FINAL TECHNICAL MEMORANDUM

TO: Dan Heilig, Wyoming Outdoor Council and
Jill Morrison, Powder River Basin Resource Council
FROM: Jean Marie Boyer, PhD, PE, Hydros Consulting Inc.
SUBJECT: Review of ERM Water-Quality Modeling Study of Boysen Reservoir
DATE: July 1, 2019

Figure 2. Wind Speed Figure from the ERM Report. Red line added at 5 m/s (9.7 knots)

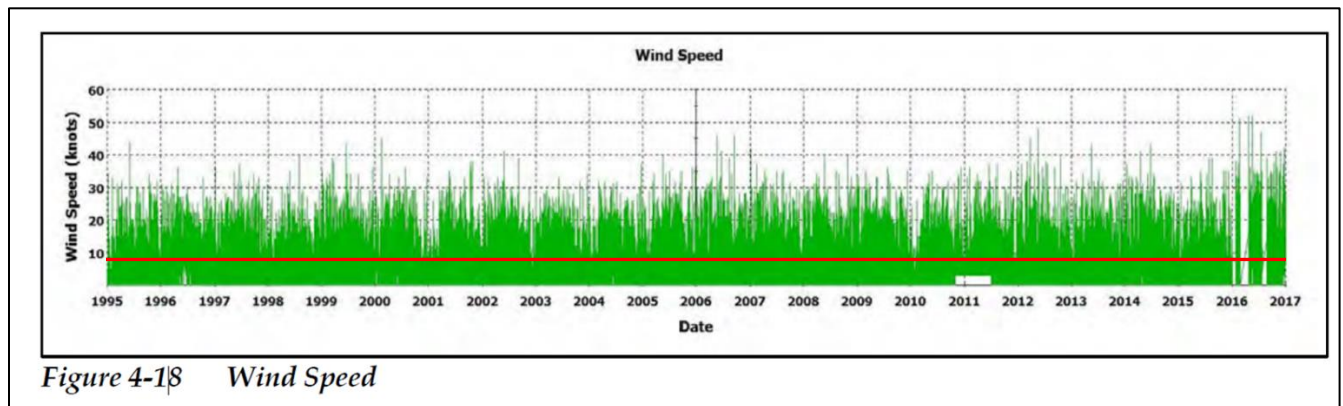
The Wind River basin experiences high wind conditions, as displayed in Figure 2 where wind speed is reported in knots. The model as delivered to Hydros by ERM is set up to “cap” wind speeds to a maximum of 5 m/s (9.7 knots) during the simulation, as indicated by the model setting in Figure 1 above.

Artificially reducing the wind speed serves to reduce mixing and increase stratification (something the model has troubles simulating). It appears that the modeler used this cap to make up for other important model development problems. This significant adjustment was not described anywhere in the Report and the reader is led to believe that the values shown in Figure 2 were used.

Figure 3. Assumed Iron Concentrations at the Wind River Above Boysen Reservoir (from Report)

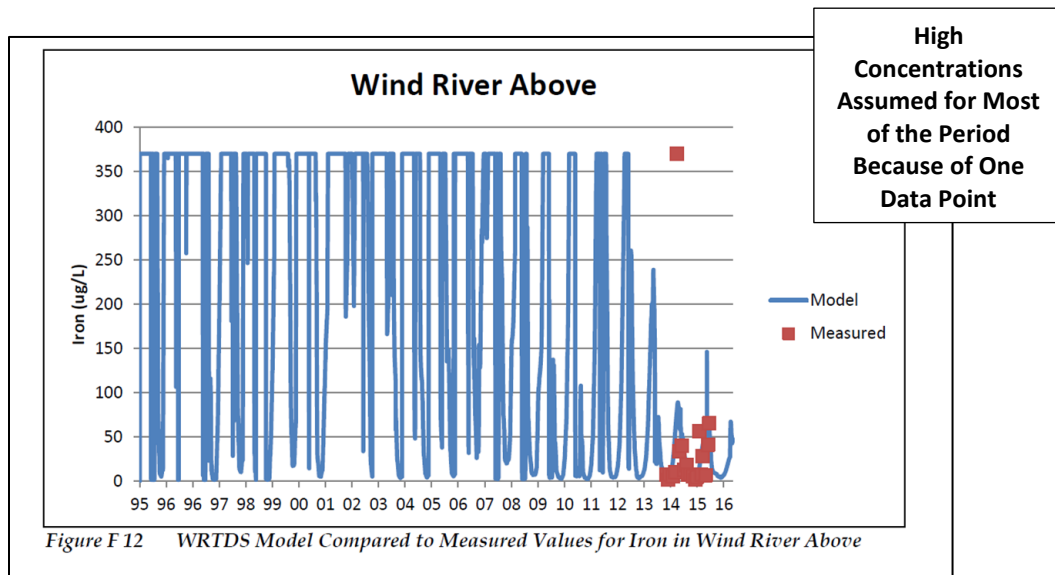
For some constituents, ERM used the WRTDS (Weighted Regressions on Time, Discharge, and Season) method to describe inflow concentrations for Wind River above the reservoir, 5-Mile Creek, and Muddy Creek (see Appendix F of the Report). The results from using this methodology are questionable and unrealistic in some cases. ERM subjectively capped what was determined to be excessively high concentrations. In addition, odd results sometimes occurred due to extreme values in a single or few data points and certain trends were created that are not described or justified. Examples are shown in Figures 3 and 4. Note that Wind River provides the majority of the inflow into the reservoir (over 70% according to Appendix C of the Report) and its water quality is an important driver of in-reservoir dynamics.

Figure 7: Temperature Calibration Figure for Outflow (from Report)

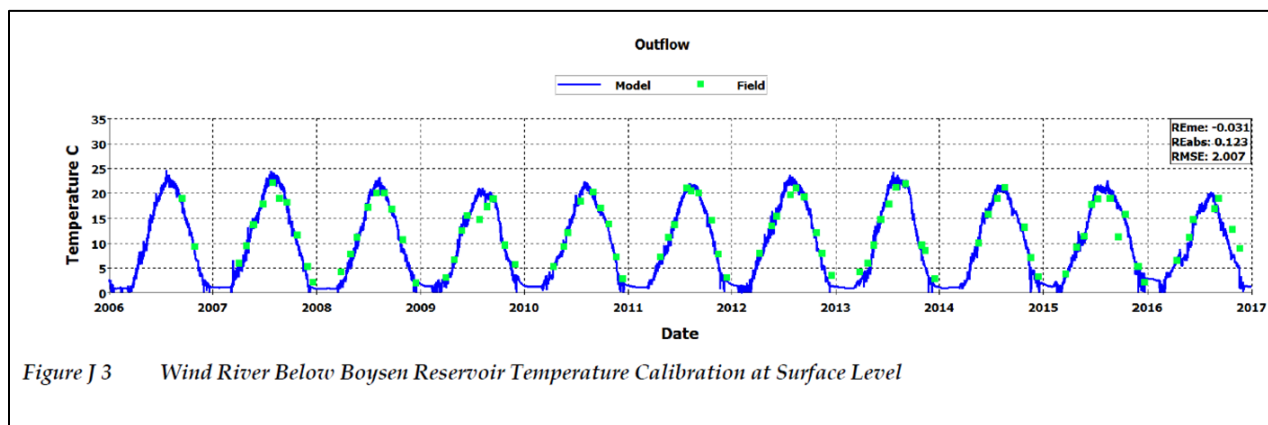
Through review of the model files, our team determined that the graphs displaying calibration and validation results for the Wind River below the reservoir are misleading and severely flawed. An example graph for temperature is shown in Figure 7. The top of the graph is labeled as “Outflow” and the caption says “Wind River Below Boysen Reservoir.” The data (green markers) are reportedly Aethon’s temperature measurements in the Wind River below the dam. The reader is led to believe that the blue line represents the temperature of the water released from the reservoir (via the low-level outlet and/or the spillway) and delivered to the river.

According to the model files, the blue line actually represents the simulated temperature at the top model layer (~top 2 feet) of the most downstream location (at the dam). This is wrong and misleading and it is unclear why this was done. Note that ERM added “at Surface Level” at the end of the caption (Figure 7) and perhaps thinking this makes it not misleading, even though there is a low-level outlet used for power production?

This is a very serious problem since the water quality at the top two feet of the reservoir is being represented as Wind River water quality and there are observed (but not simulated) vertical variations in the reservoir. In reality, the water quality at the top of the reservoir is often different from the bottom of the reservoir⁵ (see Figure 6). Since water is removed predominantly through the low-level

Figure 10: Proportion of Produced Water in the Inflow from Badwater Creek into the Reservoir

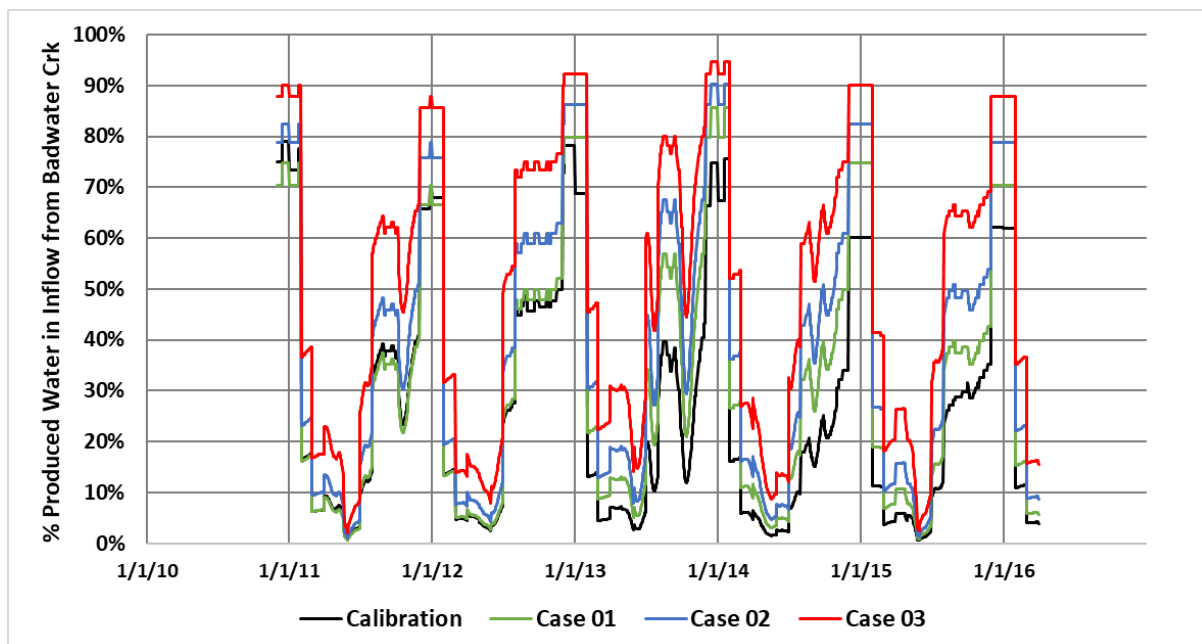
The percent of produced water in the inflow from Badwater Creek into the reservoir (using flows from ERM input files) is displayed in Figure 10. Results from the calibration model run are shown along with the three compliance analysis cases considered by ERM. Large increases are seen in July and August and maximum levels are reached in December and January. The highest percentages occur in the winter months and reach values of over 90% produced water under Case 03 (the case considered in the Statement of Basis). These periods are when “maximum concentrations entering Boysen Bay and the reservoir” occur, as noted by ERM. We acknowledge that a portion of the water is to be treated, but also note that concentrations of several constituents are not reduced via treatment (examples include arsenic, chromium, nickel, magnesium, manganese, copper, sulfide, and mercury – Table 6-4 in the Report).

Winter conditions are critical for this analysis and ERM’s exclusion of winter data is unwarranted and wrong.

Figure 11. ERM’s Figure Showing Observed and Simulated Temperature Profiles

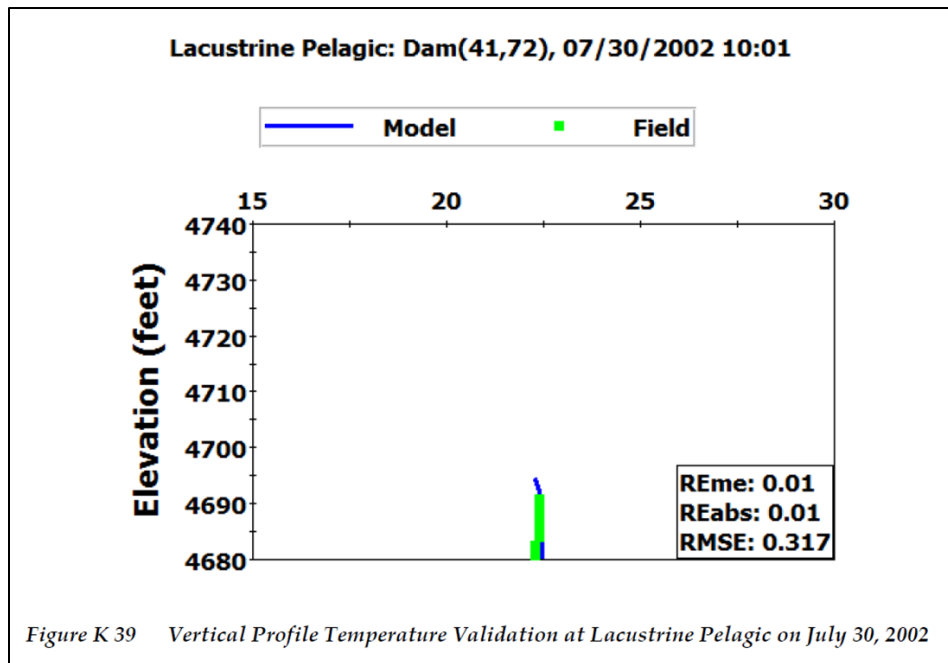
In-reservoir observed and simulated results are shown in the Report in Appendices J and K for temperature, TDS, and pH with depth. All of the graphs provide data and results for elevations above 4,680 feet. This elevation is not at the bottom of the reservoir (at least near the dam) and cutting off the elevations in the figures leads the reader to assume that the reservoir is typically well-mixed summer and does not stratify or have much vertical variation. In addition, the model results show something similar. An example is shown in ERM’s Figure K 39 (Figure 11) for July 30, 2002 near the dam, where the reservoir appears to be well-mixed with good model predictions (and hot from top to bottom).

Figure 12. Full Profile at the Calibration Site Closest to the Dam

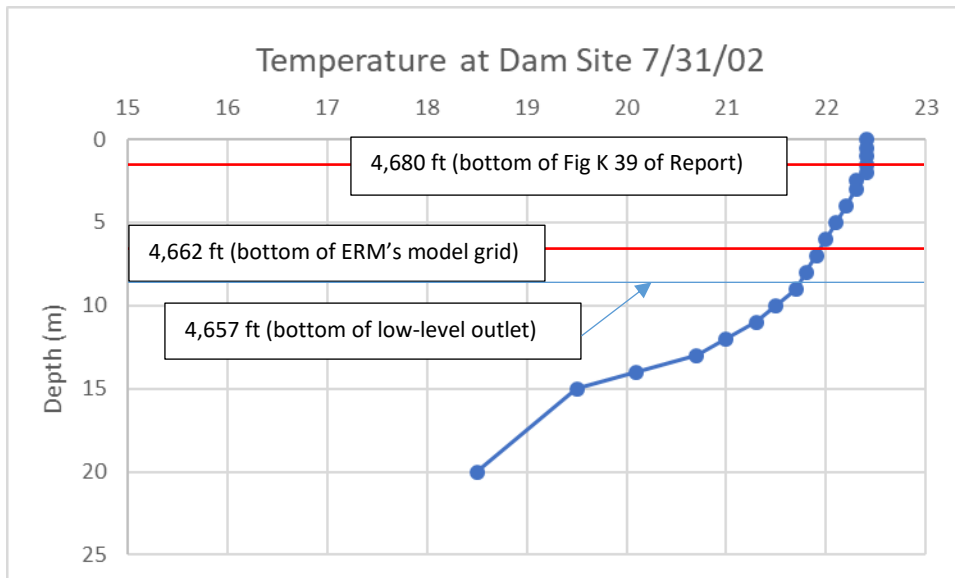
However, the full profile of observed data indicates stratified conditions (Figure 12). In addition, Figure 12 shows that ERM failed to display about 90% of the observed profile. The bottom of ERM’s model grid

at the calibration location is also indicated, showing that the model grid is not deep enough near the dam. Nor is it deep enough to reach the lower-level outlet. This also highlights significant issues with the development of the model grid (which isn't deep enough to reach the lower-level outlet).

Figure 13. Example Temperature Profiles Displaying All Observations and Model Results from Top to Bottom of the Reservoir. Data from Lacustrine Pelagic: Dam Site

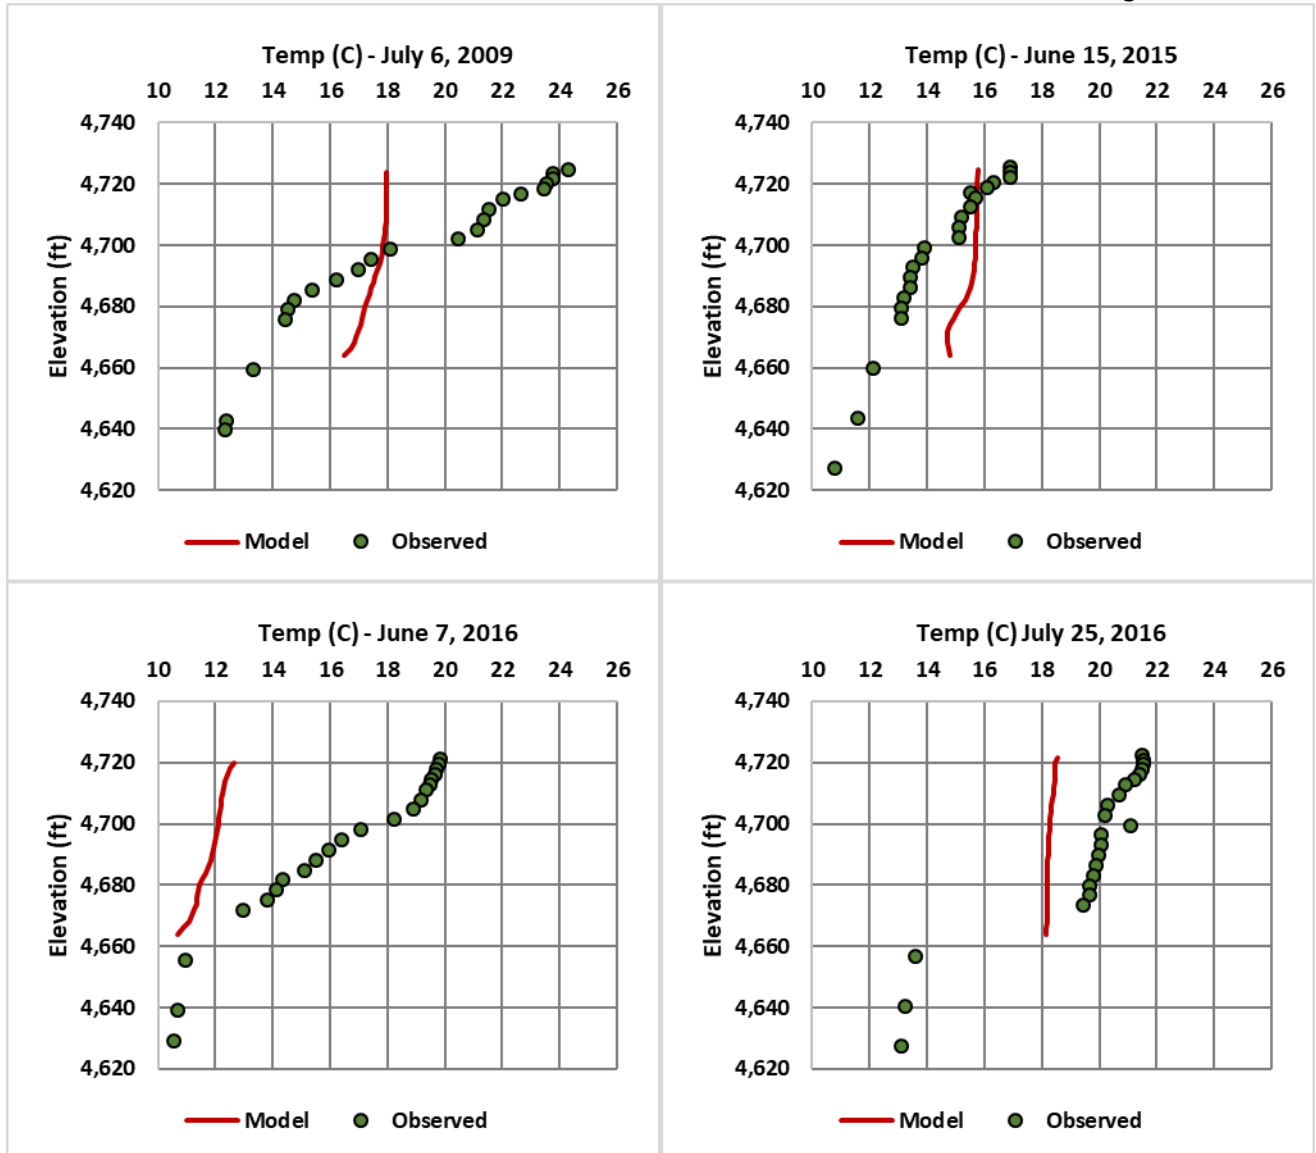
Even though a number of adjustments were made during model development and calibration, the model results are very poor. Temperature profiles near the dam (Figure 13) show that the model is not capturing observed stratification in the summer and shows very little variation top to bottom. Reservoir temperature calibration is an initial and very important step in modeling. Recall that water in Boysen Reservoir is released to the Wind River via a low-level outlet (elevation 4,657 ft) and an upper spillway, at times. This makes it even more critical to be able to capture the vertical variations. As described earlier, using commonly-accepted calibration targets, the ERM model is not adequate for use. Also note that the bottom of the model grid at this calibration location is so high that water in the bottom 35 feet of the reservoir is ignored. Thus, water quality in this region (near the lower level OLW) is not even simulated.

Instances where modeled outflow temperatures to the Wind River correspond closely with observed temperatures downstream are strong indications of poor reservoir model performance. This is because the observed temperatures were compared to the temperatures at the top 2 feet of the reservoir near the dam, as described previously. The observed downstream temperatures should be the result of outflows that depend on release location (low level outlet, spillway), amount released at that location, and vertical density distribution. Thus, even when the reported model results seem to be acceptable, they are not generated as a result of a physically realistic simulation. This renders modeled predictions at the Wind River Class I segment unreliable.

Figure 14. Example Specific Conductivity Profiles Displaying All Observations and Model Results from Top to Bottom. Data from Lacustrine Pelagic: Dam Site

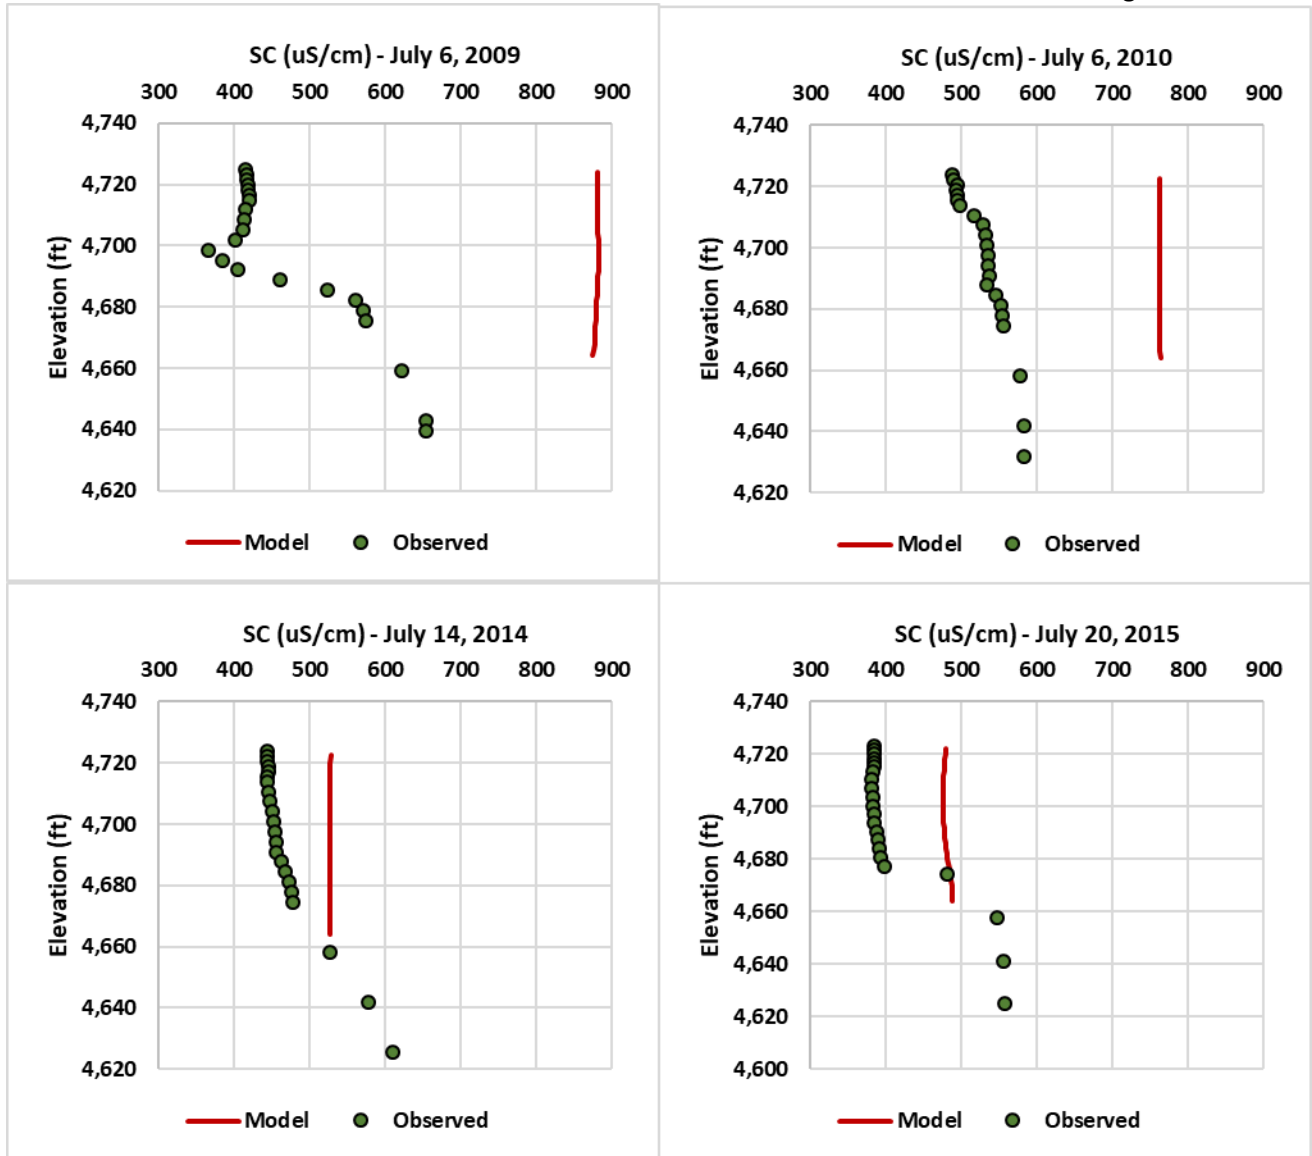
Specific conductivity profiles are shown in Figure 14. Again, the vertical variations are not captured and sometimes the magnitudes are overestimated by 100's of uS/cm. Note that most of these are in mid-summer, when the % produced water increases (see Figure 10).

Figure 15: Chloride Observations in the Wind River below Boysen Reservoir (2010-2016)

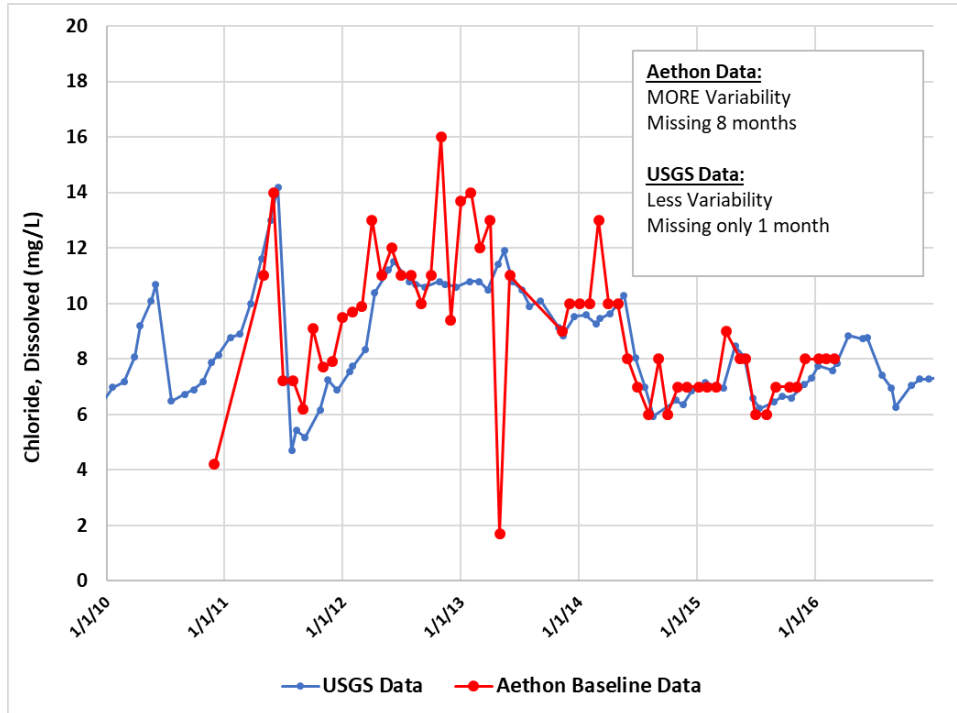
Only Encana/Aethon-collected data were considered when defining baseline conditions for the Class I segment of the Wind River. Yet, there are hundreds of approved water-quality measurements from the USGS below the reservoir for the period ERM defined as baseline (December 2010 – March 2016). Approved USGS data are considered to be of very high quality. In some instances, there are more data from the USGS in this period (Encana/Aethon did not report data for 8 months of the baseline period; Figure 15). In addition, there is much more variability in much of the data collected by Encana/Aethon than the USGS (see Figure 15 as an example). This variability would serve to increase a standard deviation.

Baseline conditions should be defined using USGS data which is of higher quality and more complete, in most cases.

Figure 16: Chloride Measurements, Wind River Below Boysen Reservoir, Aethon Data. Individual Measurements (Left); Lumped Average Monthly Values (Right); Illustration of Reduction in Variability.

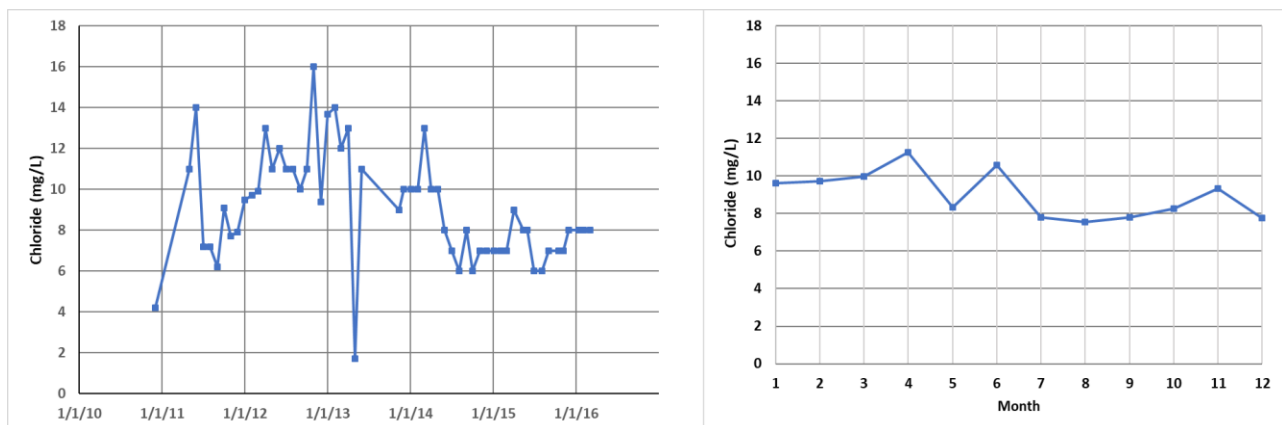
ERM chose to complete the compliance analysis on an average monthly basis. So, all Januarys are averaged together, Februarys are averaged together etc. This method lumps the data, reduces observed variability, and also serves to hide important differences that occur year-to-year, especially since time-series of the results are not displayed. This point is illustrated for chloride in Figure 16.

For the example above (Figure 16), the SD for the un-lumped data (left) is 2.7 mg/L, while the SD for the lumped data (right) is 1.2 mg/L. This makes a considerable difference in the antidegradation analysis, since the larger SD allows for larger decreases in water quality (Figure 20).

Figure 17. Model Output for “Outflow” (Top 2 ft of the Reservoir); Model Calibration and Case 01

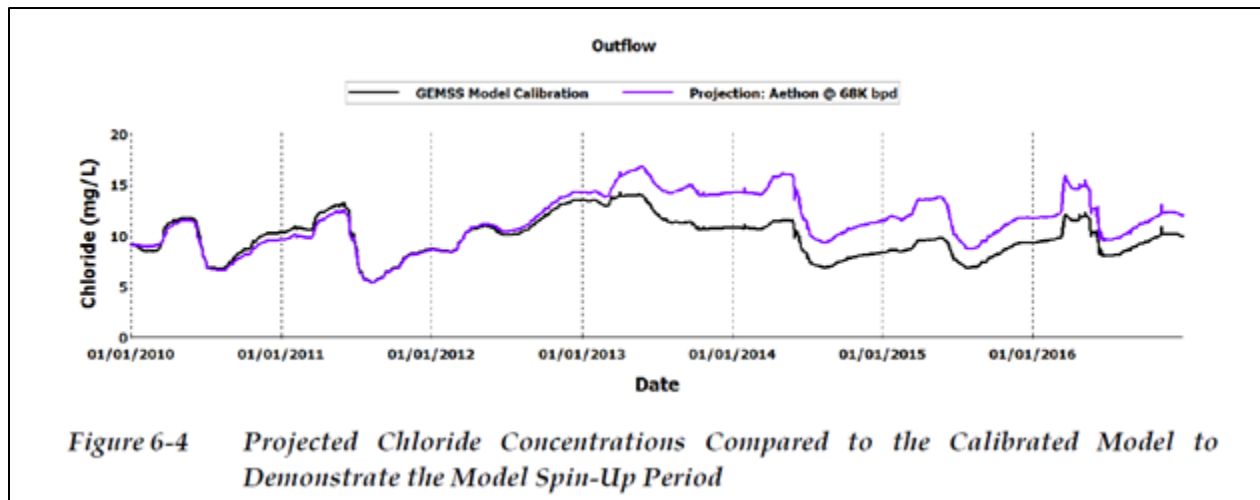
ERM did display chloride results in an attempt to justify the model “spin-up” period and to only focus on model results from December 2010 – March 2016 (Figure 17). Note that the project results in lower chloride concentrations in the “outflow” (top 2 feet of the reservoir) in 2010-2011.

Because the projection flows (68,000 bpd; Case 01) are lower than what actually occurred in 2010 and 2011, the model shows an improvement (lower concentrations) with the project. Starting in 2013, when the projection flows are much higher than the actual, the model shows some significant increases in concentrations (Figure 17).
